<b>Location:</b>	<b>1431 Franklin Street</b>
<b>Assessor's Parcel Number:</b>	008 062100807
<b>Proposal:</b>	Major Conditional Use Permit and Regular Design Review to construct a 27-story (425-foot tall) 419,480 square feet office tower with a parking garage above grade.
<b>Applicant:</b>	TC II 1431 Franklin, LLC
<b>Phone Number:</b>	Kyle Winkler, Tidewater Capital, (510) 290-9901
<b>Case File Number:</b>	PLN20124
<b>Owner:</b>	TC II 1431 Franklin, LLC
<b>Planning Permits Required:</b>	Major Conditional Use Permit for large scale development; Regular Design Review
<b>General Plan:</b>	Central Business District
<b>Zoning:</b>	CBD-P Central Business District Pedestrian Retail Commercial Zone Height Area 7, no limit
<b>Environmental Determination:</b>	Determination Pending, Environmental analysis to be conducted prior to any discretionary action.
<b>Historic Status:</b>	Project site is located within an existing listed National Register historic resource, the Downtown Historic District Area of Primary Importance (API).

# LANDMARKS PRESERVATION ADVISORY BOARD

Case File: PLN20124  
Applicant: TC II 1431 Franklin, LLC  
Address: 1431 Franklin Street  
Zone: CBD-P  
Height Area: 7, No l

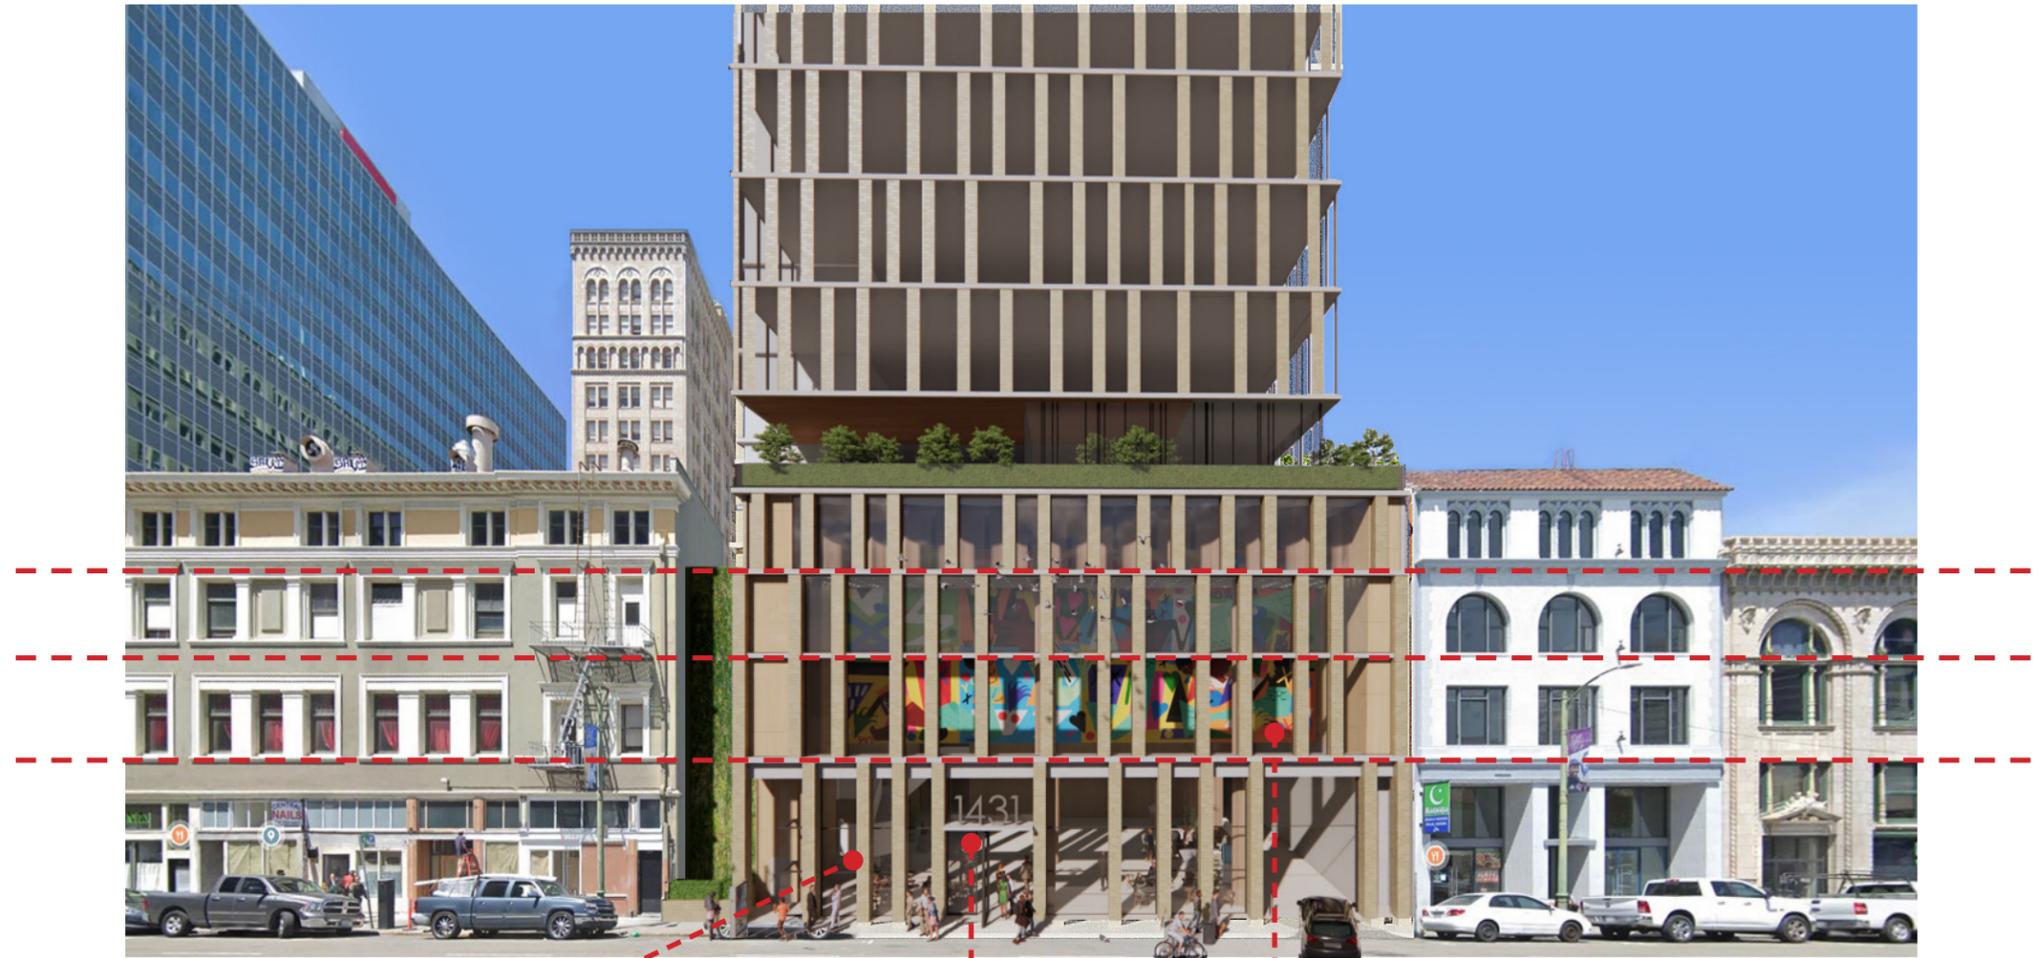
The height of the floor levels of the base relate to the horizontal details of the adjacent buildings, but box design of the building and the “gradient pattern” with wider glazed windows and wide columns at ground level is in contrast to buildings in the API. Staff is concerned with the challenge of maintaining high quality materials for the proposed fenestration and an adverse effect on the API.

The revised design has adjusted the floor levels of the base to relate to the horizontal details of the adjacent buildings. The windows at the base have been widened to open up the lobby and to coordinate with the adjacent buildings and the API.

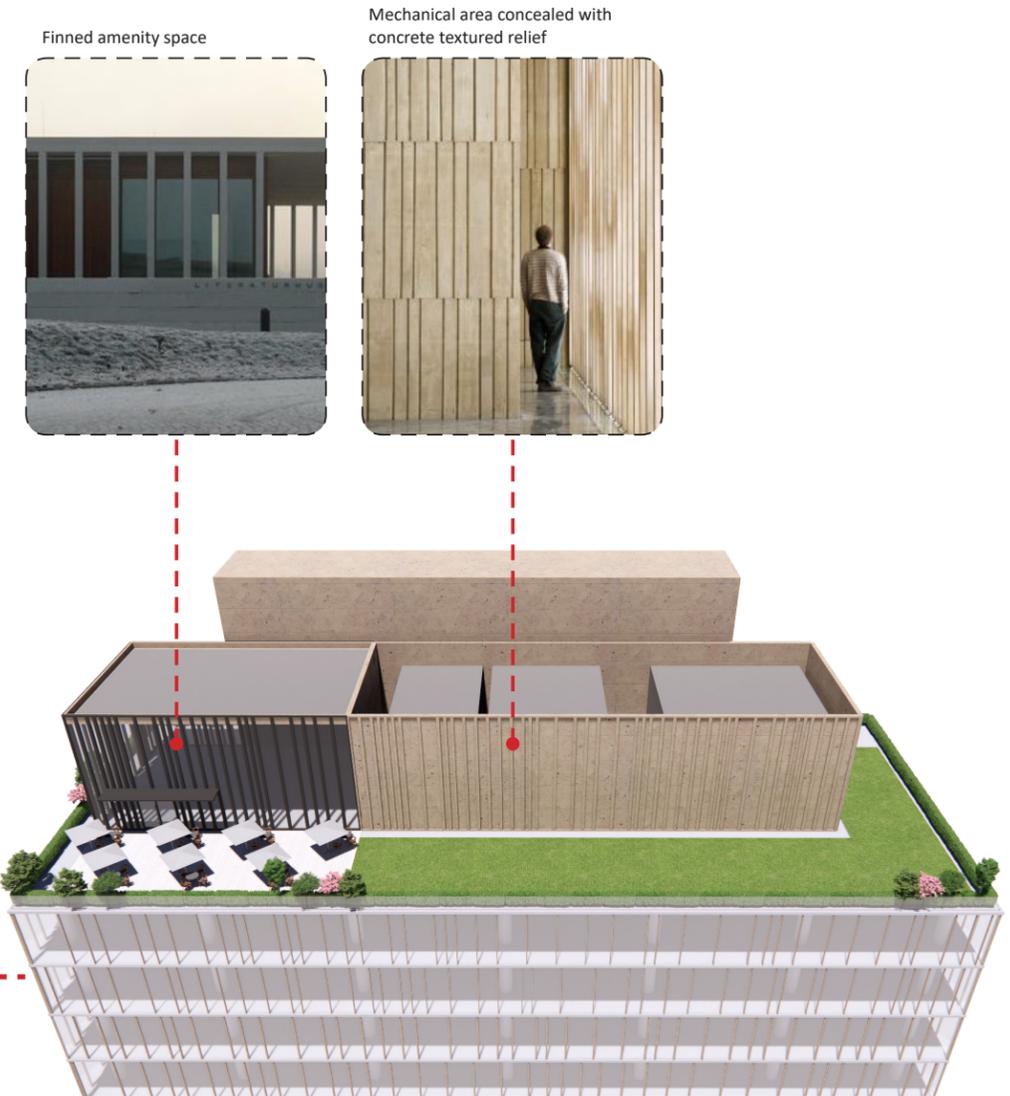
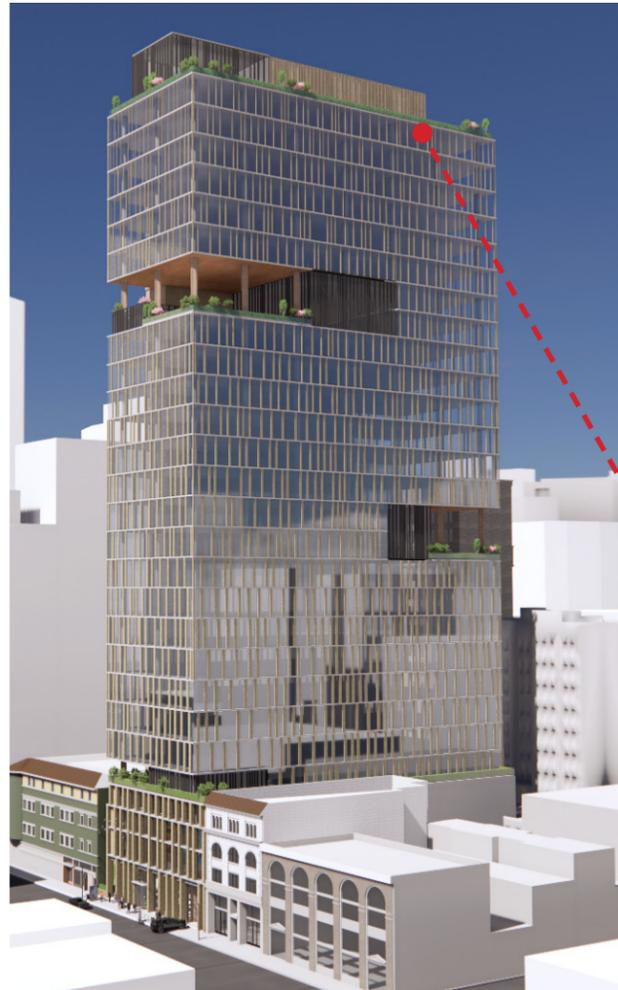
The proposed green space concept on the roof does not supply details on proposed materials, roof line decoration or design, or floor plan.

Section 5.4.2 continues to on to say, 'Rooflines should have shapes, materials, and colors that relate to the rest of the building, while still being differentiated to achieve an upper terminus.' Though I understand where this logic comes from, I would also note that in the Oakland guidelines they go on to say, 'In general, each applicable guideline should be met to approve a development proposal. However, this document is not intended to restrict innovation, imagination and variety in design.' Providing a roofline that differentiates to achieve an upper terminus really applies to a mid-century modern highrise but not necessarily to all buildings of today. Which is why our solution for the proposed project is based more in a non-classical building terminus. In other words, instead of the building having a cornice or capital like a classical column the design of many buildings today are pattern or volume oriented. In fact, some almost do the opposite, with the top fading away to less than what it was. Below are a couple examples of both directions. That is not to say a building with a cornice is the wrong direction, we are simply noting that the guideline stated here is a recommendation that should be viewed as one option.

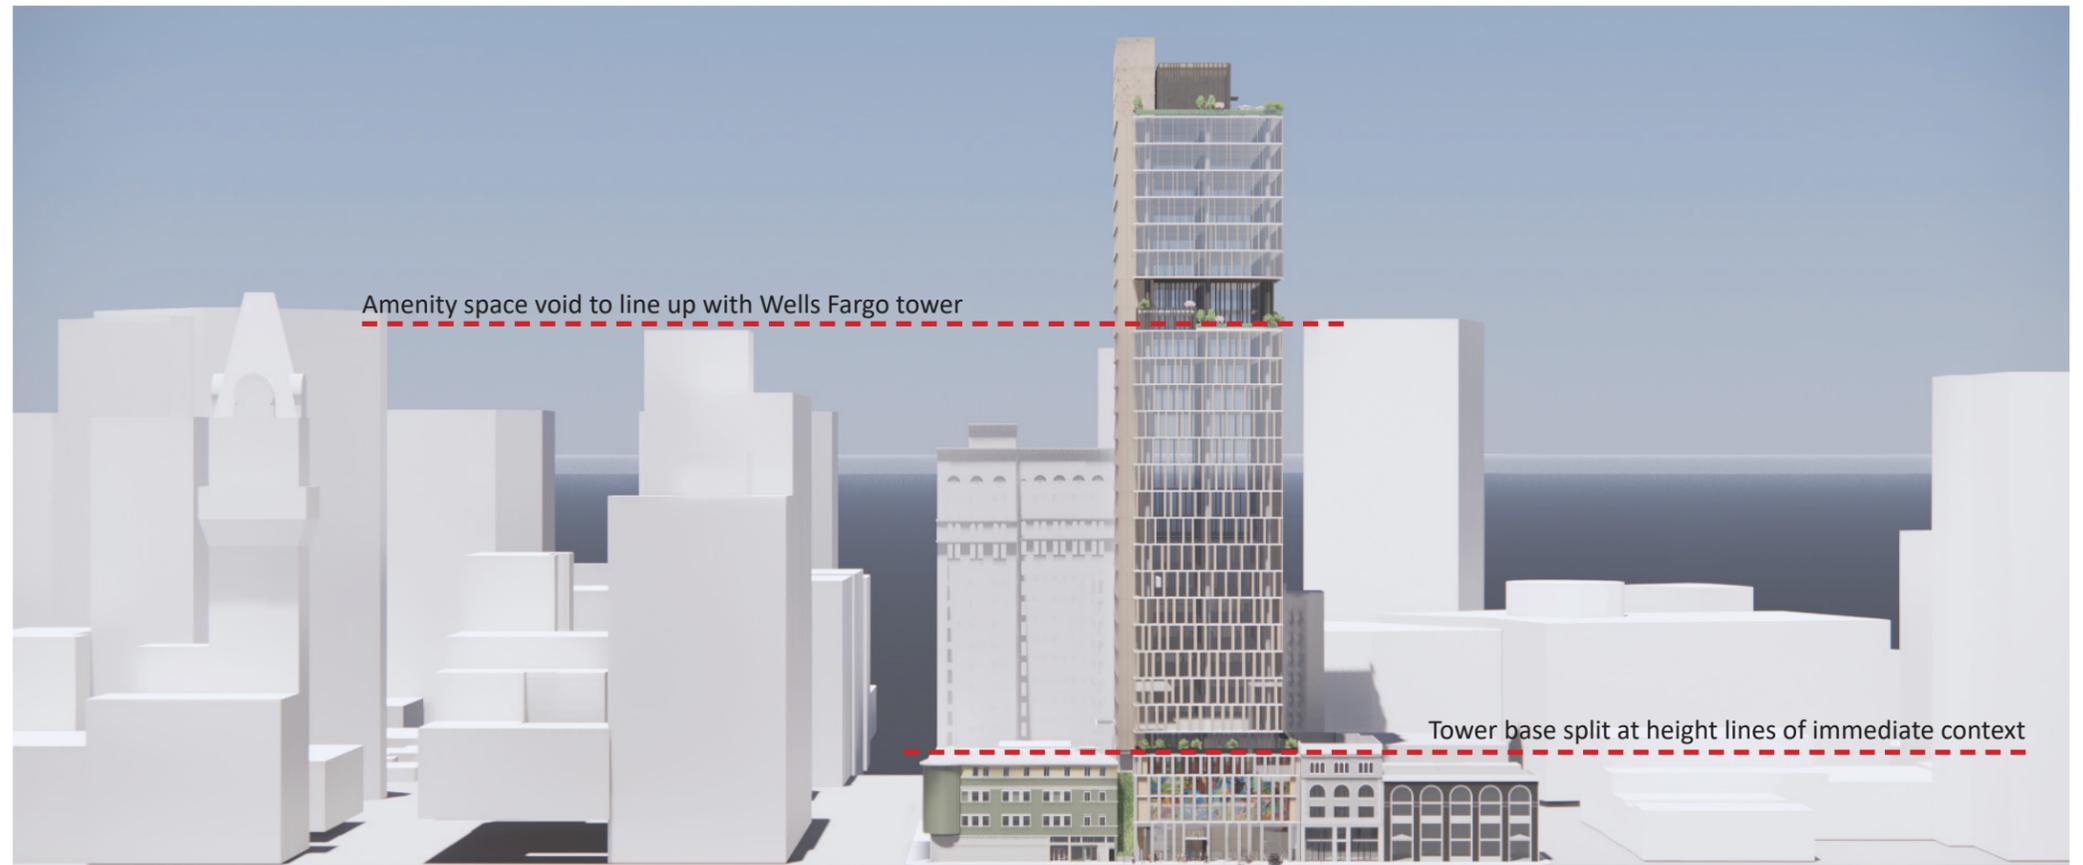
The proposed design does not meet this finding. The proposal does not provide information on the operating characteristics of the development (parking, security, way finding, etc.) which may adversely affect the livability of the abutting properties and surrounding neighborhood.

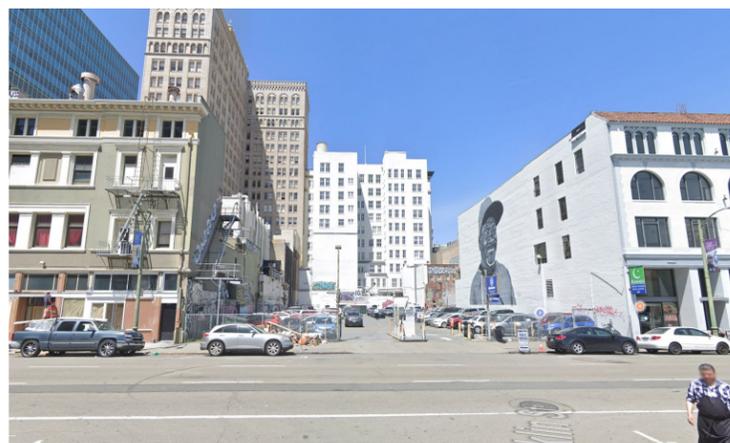
The proposed design does not meet this finding. The proposal does not provide evidence of consideration given to texture, materials, colors, and appurtenances in relation to the surrounding vicinity.

The area immediately adjacent to the proposed project is filled with a large variety of different types of projects. To try and define an appurtenance that would best typify the area is probably not possible. Within a block radius of the proposed site a 400-foot-high tower without windows at the lower 5 floors, a modern tower recently completed with an all-black glass façade, a mid-century modern reflective glass Highrise building, a Greek revivalist building, a gothic revivalist building, Italianate Villa style building, a neo-Moorish style building, a Spanish colonial revivalist style building and pretty much any other imaginable esthetic built between 1850 and today.

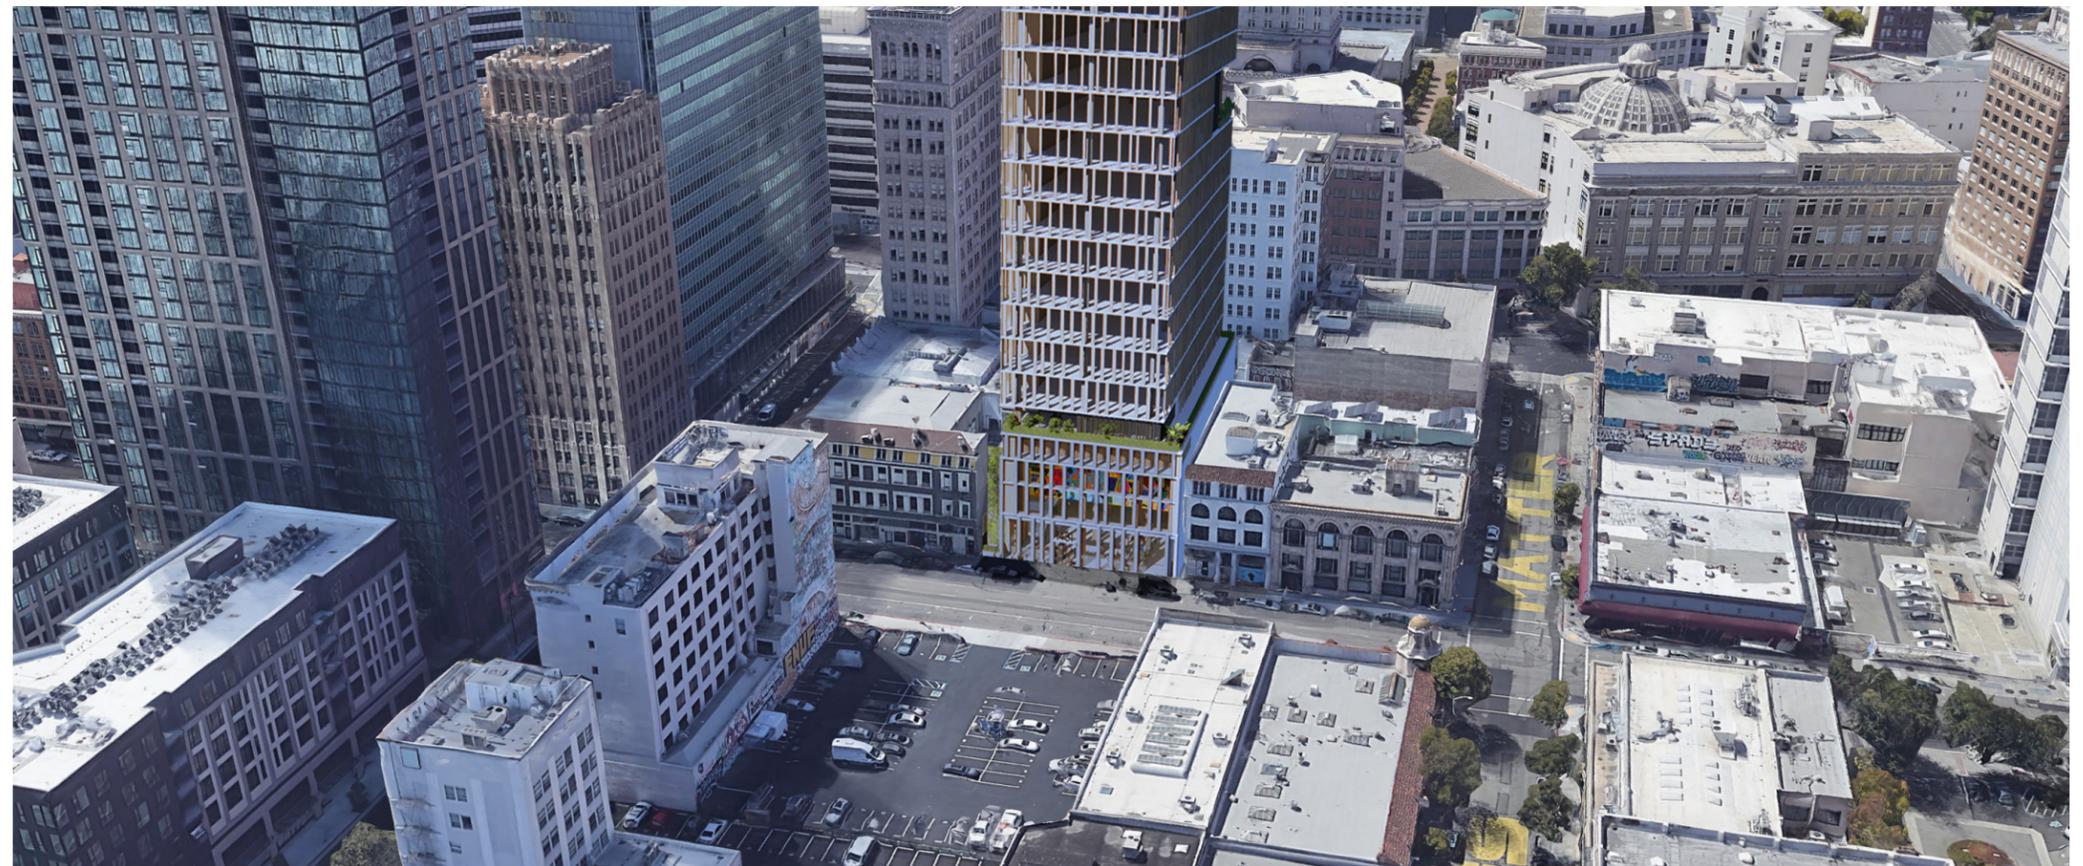
The proposed design lacks enough detail to discern its compatibility with the character of the neighborhood.

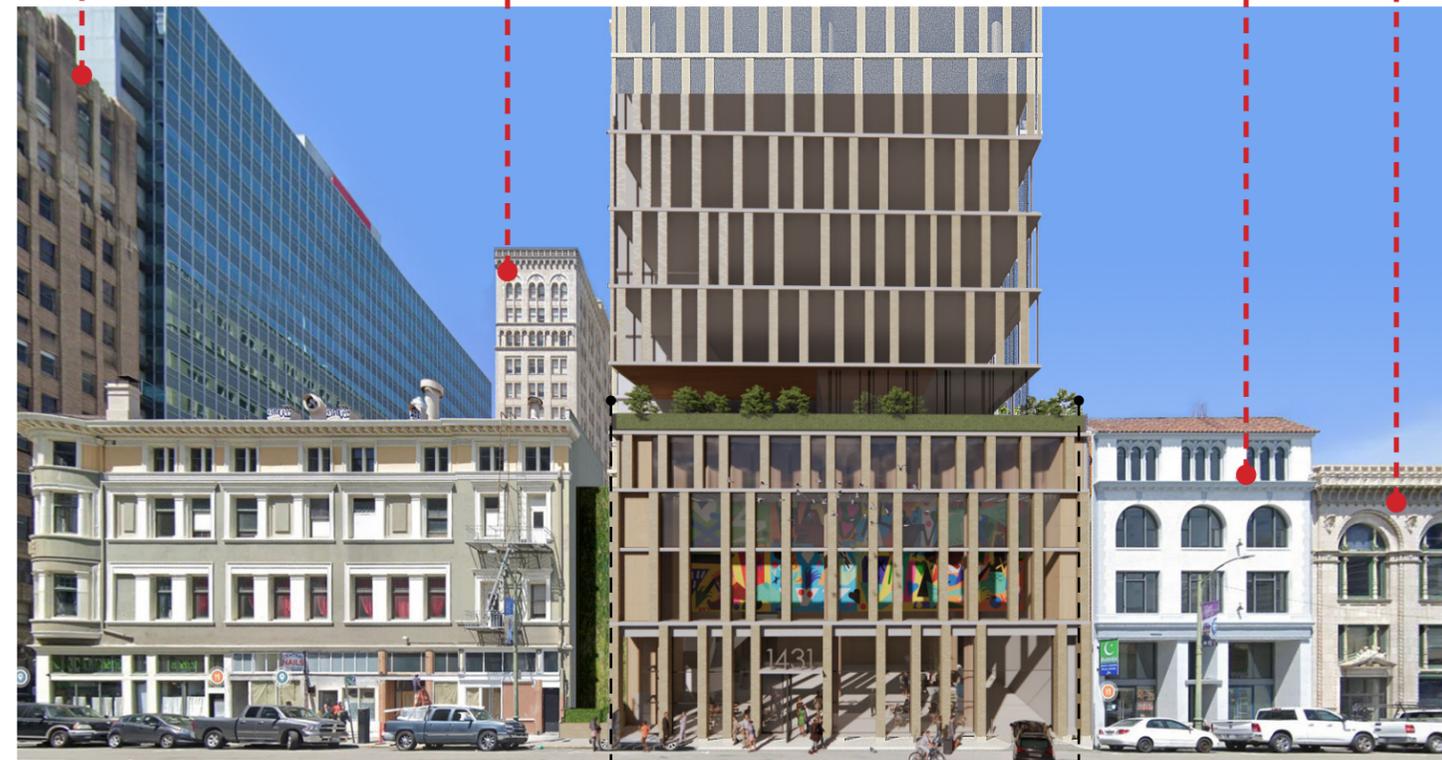
The proposed base of the tower does not conform to the API in rhythm, composition, or patterns of openings. More details must be provided on the ground floor lobby.

The base of the building has been redesigned to better reflect the widths and rhythm of the facades on the street, and entrances that reflect the patterns on the street. As previously noted, the revised design of the proposed building has a strong relationship to the adjacent buildings in terms of massing and, it's modern interpretation to the predominately classical horizontal layer that exists in the Historic district. The pattern of windows also mimics the window layout of the adjacent buildings in a modern way. In addition, the base of the proposed building will have a traditional brick base to pick up on the similar use of materials that are prevalent on the adjacent buildings in the Historic District. In addition, we have located key cornice lines to match the adjacent buildings. But it is worth noting that the cornice lines of the two adjacent buildings are not at the same height or size. With this in mind, we elected to split the difference and make for a compromise geometry that is intended to be visually as cohesive as possible.
